# ASSESSMENT REPORT

## Moolarben Coal Mine Section 75W Modification

Figure 3: Proposed Rail Loop Design

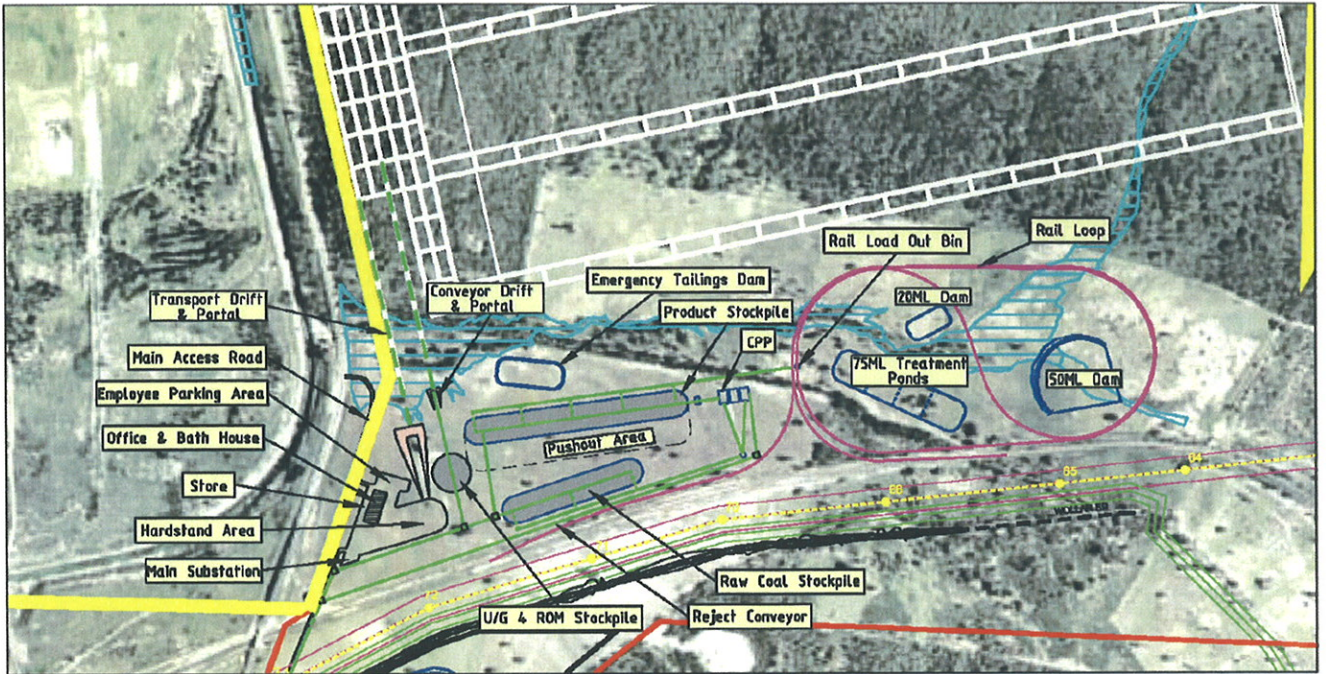
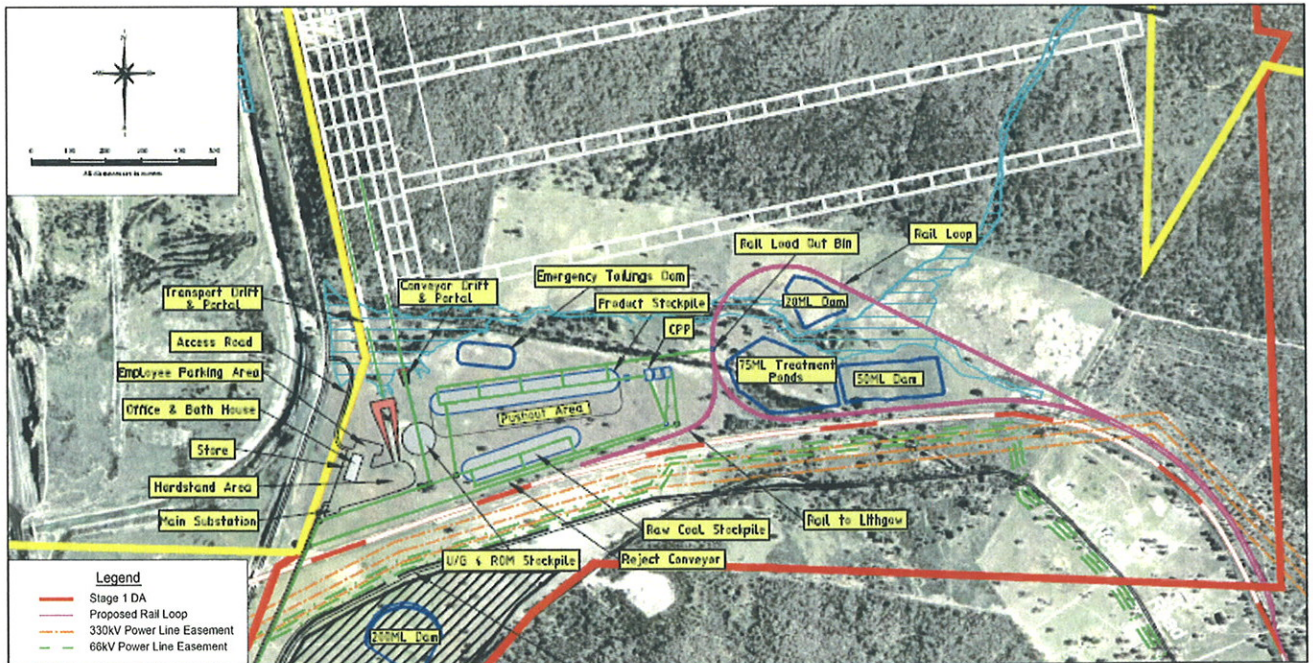
While this large proposal is being assessed, Moolarben is also seeking to modify the approval to allow the approved rail loop to be reconfigured (see Figures 2 and 3).

The modified rail loop design has been enabled by Moolarben's recent acquisition of several properties to the west of the rail loop.

It has several advantages over the original design, in that it:

- reduces the footprint disturbance area by approximately 1.3 hectares (ha);
- provides better rail loading conditions because it is on a more level gradient;
- reduces capital and operating costs for Moolarben (estimated cost savings of approximately \$0.75 million due a 500m shorter track distance).

The design of the modified rail loop would also require some minor changes to the shape and location of an approved 50 Megalitre (ML) groundwater storage dam and an approved 75ML groundwater treatment pond, both situated within the balloon loop. The function and capacity of both water facilities would remain unchanged.

**Figure 4: Site Vegetation**

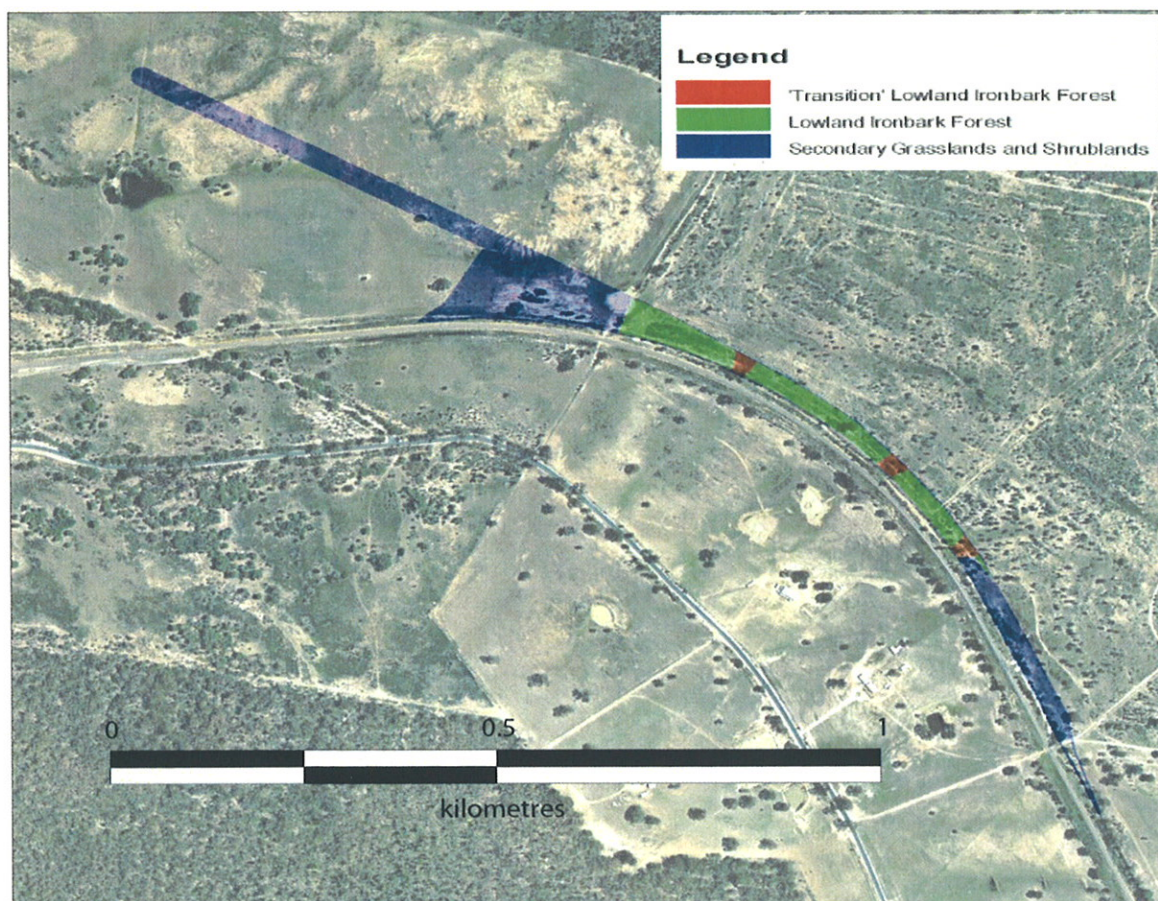
An Ecological Assessment was conducted by Ecovision Consulting Pty Ltd. The assessment found that the proposal would result in the clearing of 6 ha of native vegetation, comprising 1.7 ha of intact Lowland Ironbark Forest and 4.3 ha of Secondary Grasslands and Shrublands (see Figure 4). The Lowland Ironbark Forest contains approximately 0.2 ha of vegetation which is considered to be White Box Yellow Box Blackely's Redgum Woodland (WBYBBRW) and Derived Grasslands EEC/Critically Endangered Ecological Community (CEEC).

Moolarben has made a series of commitments to avoid, manage and mitigate these impacts. Most notably, the company proposes to compensate for the loss of additional EEC/CEEC by increasing the approved offset area from 130 ha to 135 ha and to revegetate an additional 6 ha of cleared land on the Red Hills property and adjoining lands.

Consequently, the Department has recommended modification of Condition 41(a) to add 5 ha to the required 130 hectares of WBYBBRW and modification of Condition 42(b) to add 6 ha to the required 143 ha of land to be revegetated. The Department is satisfied that the Rehabilitation & Offset Management Plan required under the existing conditions of approval would provide adequate long-term management of these areas.
